**COMMONWEALTH OF KENTUCKY
BEFORE THE KENTUCKY STATE BOARD
ON ELECTRIC GENERATION AND TRANSMISSION SITING**

**In the Matter of the Application of Glover Creek Solar,)
LLC, for a Construction Certificate to Construct a) Case No. 2020-00043
Merchant Electric Generating Facility)**

**RESPONSES TO SITING BOARD STAFF'S
FIRST REQUEST FOR INFORMATION ON REHEARING**

CASE NO. 2020-00043
GLOVER CREEK SOLAR, LLC
RESPONSES TO SITING BOARD'S FIRST REQUEST FOR INFORMATION
ON REHEARING TO GLOVER CREEK SOLAR, LLC

(figure extracted from attached reference USDA Forestry Service Data Sheet)

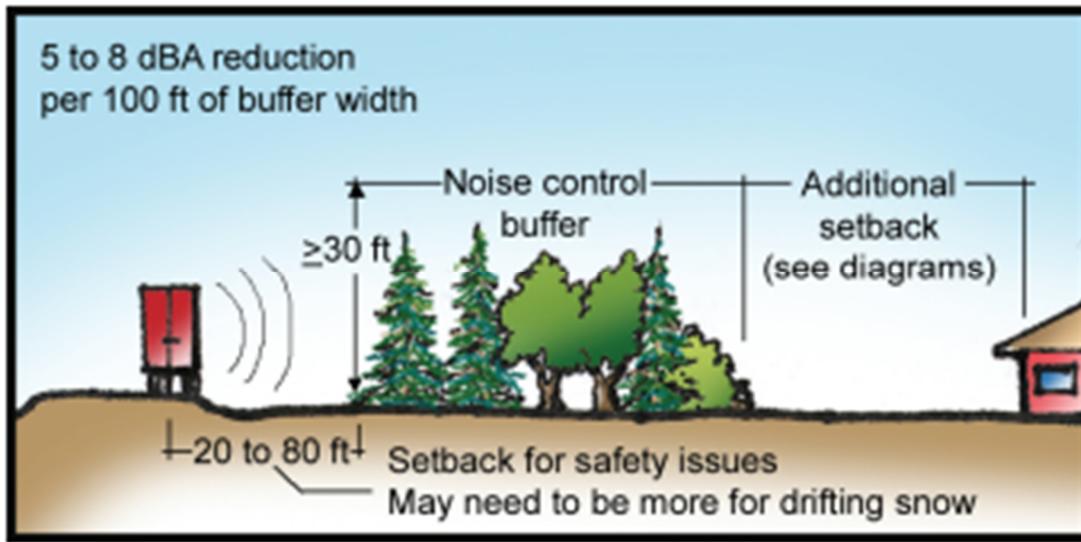
Provide an explanation as to what would be considered an industry best practice as it relates to planting vegetative buffers to mitigate against noise and visual issues.

For example, "substantial" noise reduction is defined by the Federal Highway Administration (FHWA) as 5-10 dBA in paragraph 722.11d (Noise Abatement) of the Highway Traffic Noise Analysis and Abatement Policy and Guidance document (provided as reference). The Department of Housing and Urban Development (HUD) under 24 CFR § 51.103 (provided as reference) also defines a similar standard of 5 dBA or 10 dBA level of sound attenuation for "Normally Unacceptable" noise zones depending on the day-night sound level averages.

As an illustration of the effectiveness of vegetative buffers with regards to sound reduction, GAI has provided further information in the form of an USDA Forestry Service Data Sheet on the noise reduction from vegetative buffers. This information is being provided for reference in lieu of comprehensive qualitative modeling. In GAI's professional experience, the data as provided by the above resources (i.e., the USDA Forestry Service document, etc.) is what would be expected when applied to real world applications.

A 100 feet of vegetative buffer (at greater than 30 feet in height) provides an estimated 5 to 8 dBA reduction of sound levels.

A 15-foot-deep vegetative buffer at either six- or three-foot in height is anticipated to provide minimal noise mitigation for a sensitive receptor. As described in the figure above, we can expect a 5 to 8 dBA reduction in sound levels per 100 feet of vegetative buffer width, assuming a vegetative buffer that is at least 30 feet tall. A double row of shrubs, whether six- or three-foot in height, would have less than a 3 dBA reduction in sound levels. Since the human ear cannot distinguish differences in noise below 3 dBA, neither a six- or three-foot vegetative buffer would reduce the noise experienced by neighbors of the solar project.

Exhibit 6 – Project Map

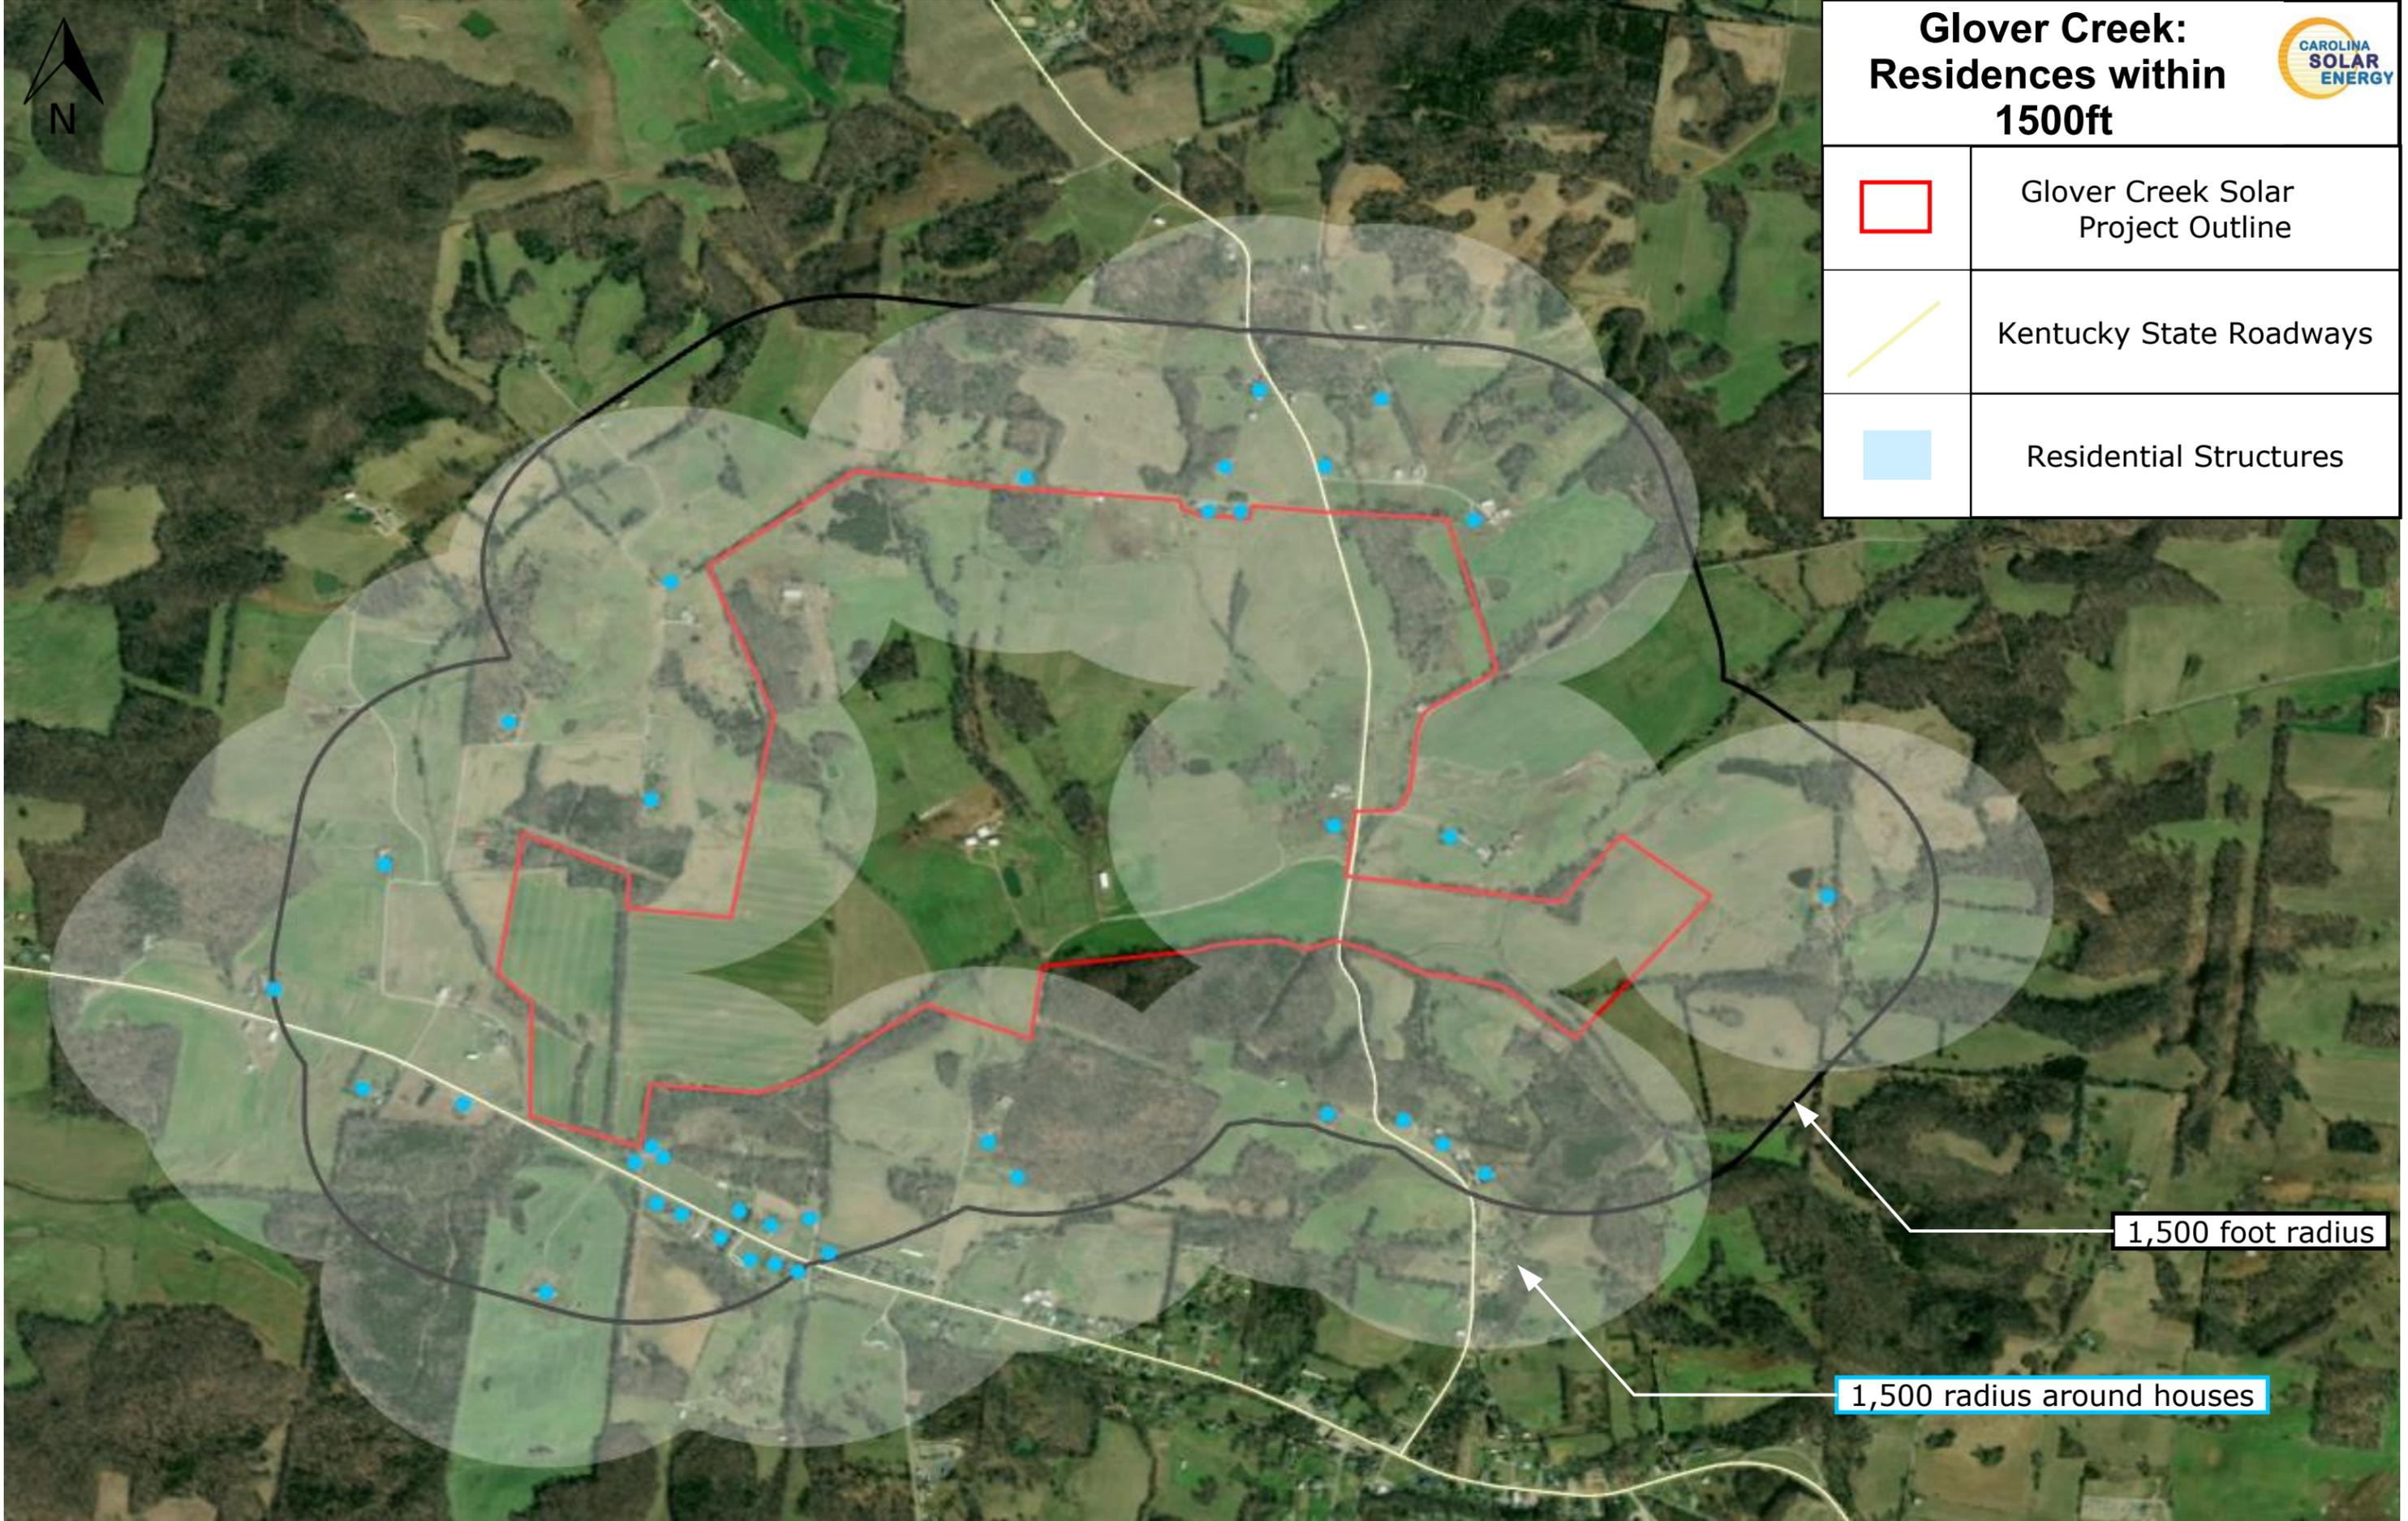
a. Provide additional information and support for the statement that “[s]cheduling all of the tamping near residences within 1,500 feet at the end of the tamping process will be inefficient and likely to cause increased costs, delays, or other unintended consequences during construction with uncertain benefit to the community.

Response: In order to see a visual image of what this would entail, please refer to the map attached as Exhibit 6. The shaded areas encompass all the sections of the solar project that are within 1,500 feet of a neighboring residential home. As you can see, there is a small, oddly shaped area in the center of the project site that is outside of the shaded area (the “Center Section”). On Glover Creek’s site plan you can see that there is a farming area in the middle of the Center Section. We are currently planning to avoid putting solar panels on this farming area, at the request of the landowner, so that he can continue to use the farming infrastructure. Additionally, there are 3 separate streams that cross the Center Section.

Another issue that may occur is that typically, racks are installed in different sections of the site in a planned way, with the installation crew and pile drivers working from one section to another. The sections are scheduled for installation based on weather conditions and ground conditions (e.g., mud, potential for erosion, ongoing civil work, etc. in each of the different sections) in different parts of the site. If conditions on the ground are not optimal to start post installation in the Center Section when post installation is scheduled to begin, the Siting Board's condition would require Glover Creek to delay post installation on the remainder of the project site until conditions allow for installation of posts in the Center Section. This delay could increase cost and cause other unintended consequences such as inability to move equipment out of the loading area so that new equipment can be delivered, because the posts are not able to be installed on schedule. In other words, if there were no limitation from the Siting Board permit on where to start post installation, the construction manager would divide the project into sections in the most efficient way, and schedule post installation based on the sections of the project site that are ready to receive posts. Not allowing for this flexibility will create inefficiency and delays, which could in turn cause delays in meeting timeline obligations under interconnection agreements with the utility or agreements with the power purchaser (these are the unintended consequences).
